Re: Notice of Violation for the Comprehensive Compliance Investigation at:
Demi John I S Water System, 207 Flounder Circle, Brazoria County, Texas
Regulated Entity No.101192078, TCEQ ID No. 0200234 Investigation No.1095457

Summary of Investigation Findings

ORBIT SYSTEMS, INC.

Subject: Public Water Supply, Demi John Island, ID#0200234, Brazoria County, Texas

GOULDS MODEL 3BF1J1A0

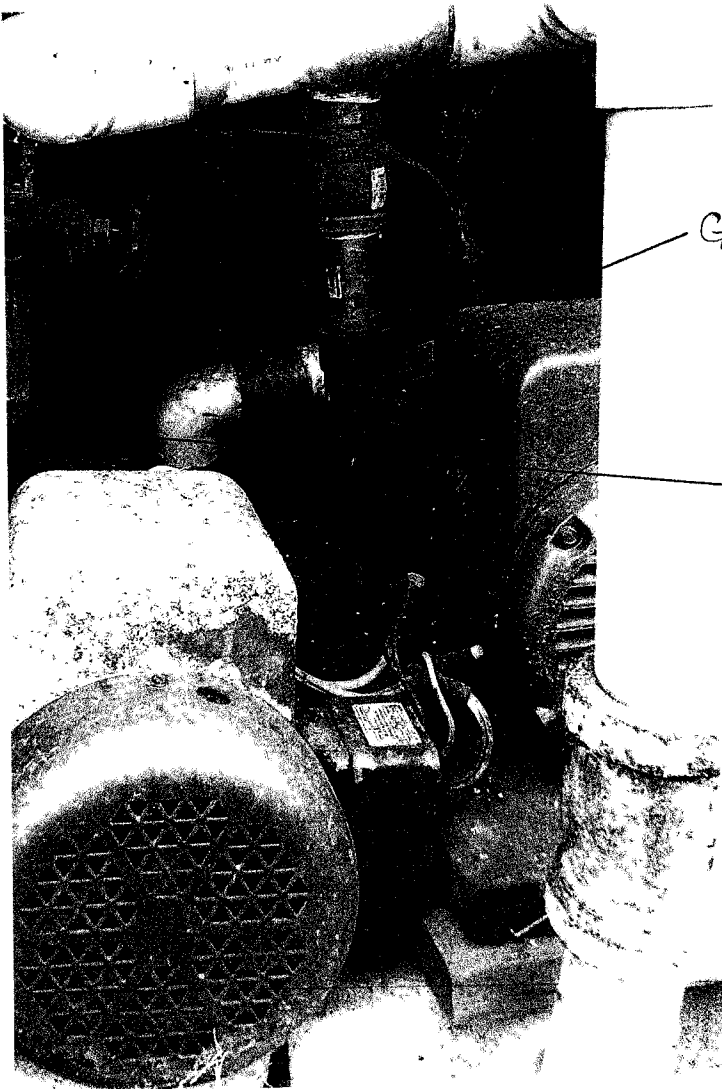
Failure to provide a minimum service pump capacity such that each pump station or pressure plane must have two or more pumps with a total capacity of 2.0 gallons per minute per connection, or a total capacity of 1,000 gallons per minute and be able to meet peak hourly demands with the largest pump out of service, whichever is less at each pump station or pressure plane.

At the time of the inspection, the facility had a total of 98 conn. and is required to provide 2 gallons per minute(gpm) per conn. Your service pumps produced a total of 166 gpm and are short a total of 30 gpm. This is calculated in the following manner:

Required 2 gpm /conn. X 98 conn. = 196 gpm Total
Short 196 gpm Required - 166 gpm Produced = 30 gpm Total

- Goulds Model 3BFIJIAO, 5 15/16" diameter impeller – At 115 ft head, pump curve shows pump capacity at 125 gpm. Please see attached photo of nameplate for this pump and corresponding pump curve..
- Myers Model 150M5, 5 15/16" diameter impeller – At 115 ft head, pump curve shows pump capacity at 125 gpm. Please see attached photo of nameplate for this pump and corresponding pump curve.

Combined capacity for the two service pumps is 250 gpm providing 2.55 gpm per connection at 98 connections. This should meet service pump capacity requirements for the subdivision.

System/pictures

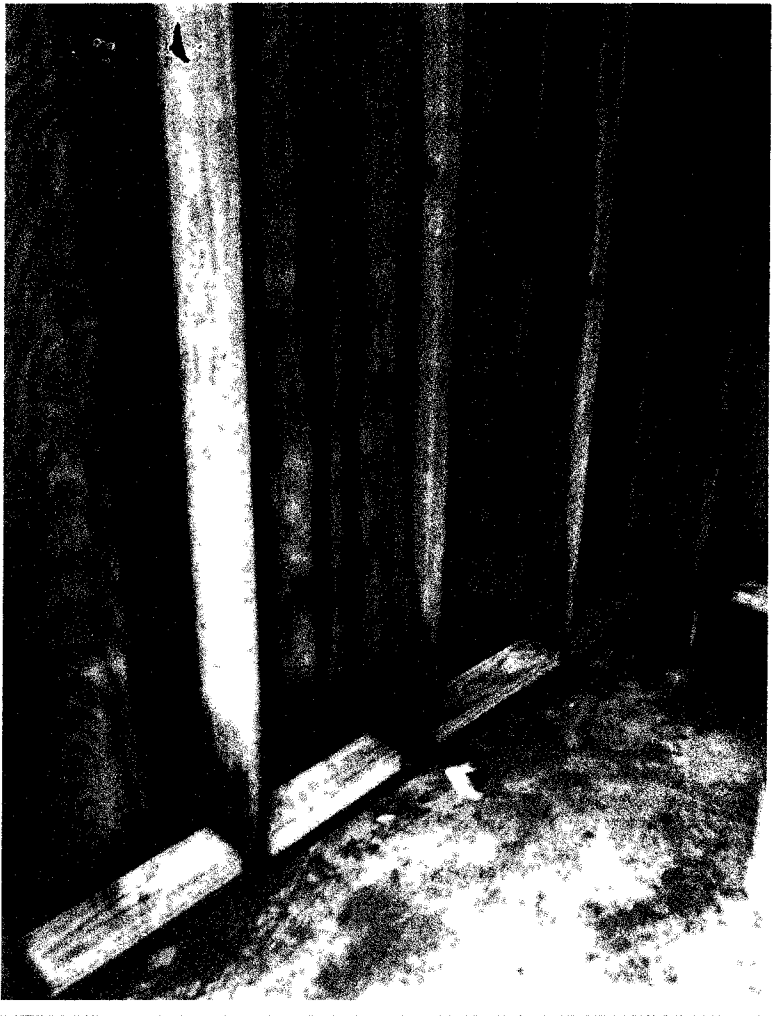
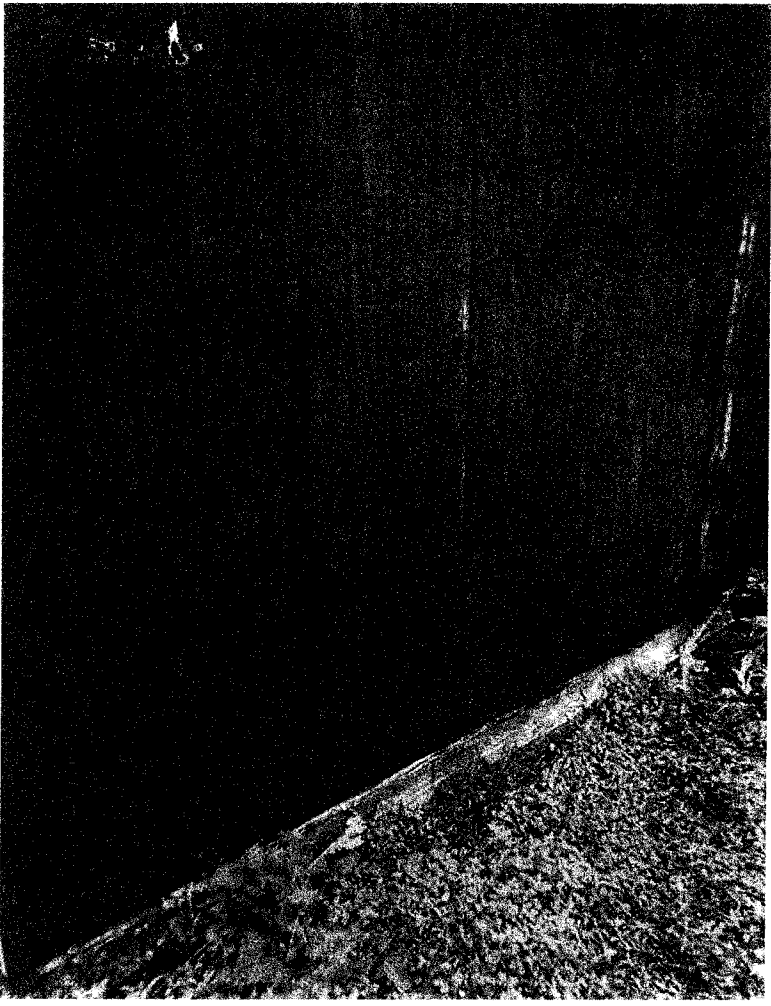
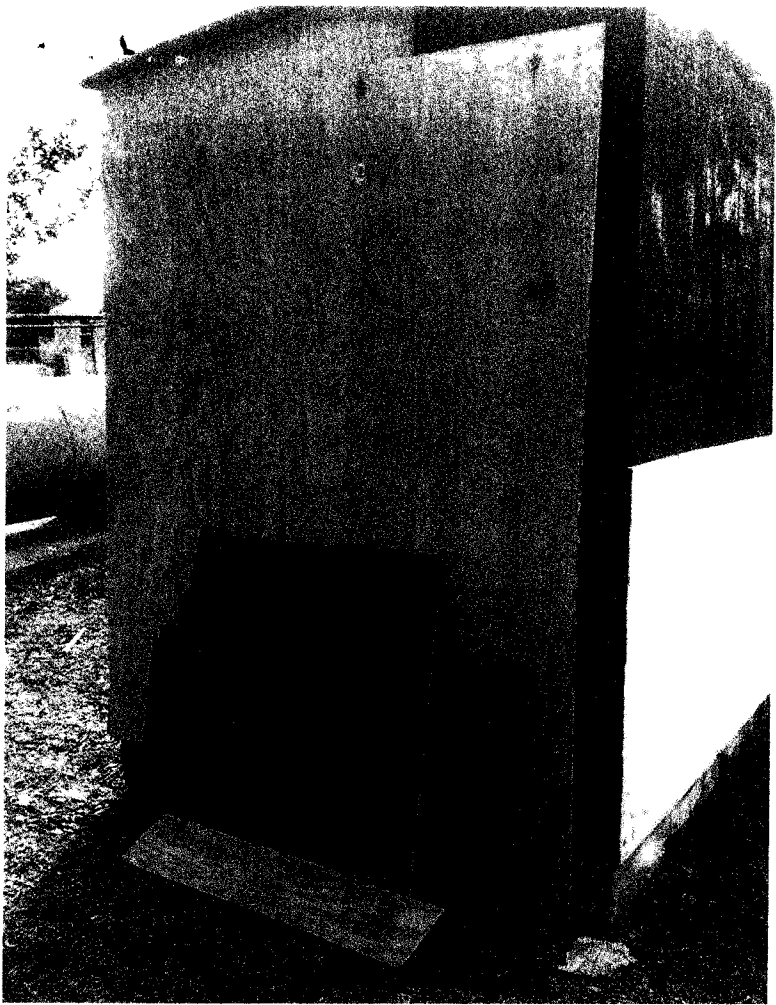
Failure to install all water system electrical wiring in compliance with a local or national electrical code. At the time of the investigation, the electrical wiring was not in a conduit.

Recommended Corrective Action: Submit copy of photos or work orders to verify that the well houses have been repaired.

- 1 Coronado (0200275): conduit in well house
- 2 Country Acres (0200274): well house repair
- 3 Colony Cove (0200324): well house repairs (pics are work in progress from Jan.30; they did finish)
- 5 Blue Sage (0200323): no issues
- 17 Ryan Long 2 (0200108): barb wire repairs
- 18 Snug Harbor (0200053): no issues in review, but we are did barb wire repair and sealed slab (no picture)
- 27 Mark V (0200432): barb wire repair
- 28 Riverside (0200058): site glass installed

- 1 Coronado (0200275): conduit in well house
- 2 Country Acres (0200274): well house repair
- 3 Colony Cove (0200324): well house repairs (pics are work in progress from Jan.30; they did finish)
- 5 Blue Sage (0200323): no issues
- 17 Ryan Long 2 (0200108): barb wire repairs
- 18 Snug Harbor (0200053): no issues in review, but we are did barb wire repair and sealed slab (no picture)
- 27 Mark V (0200432): barb wire repair
- 28 Riverside (0200058): site glass installed
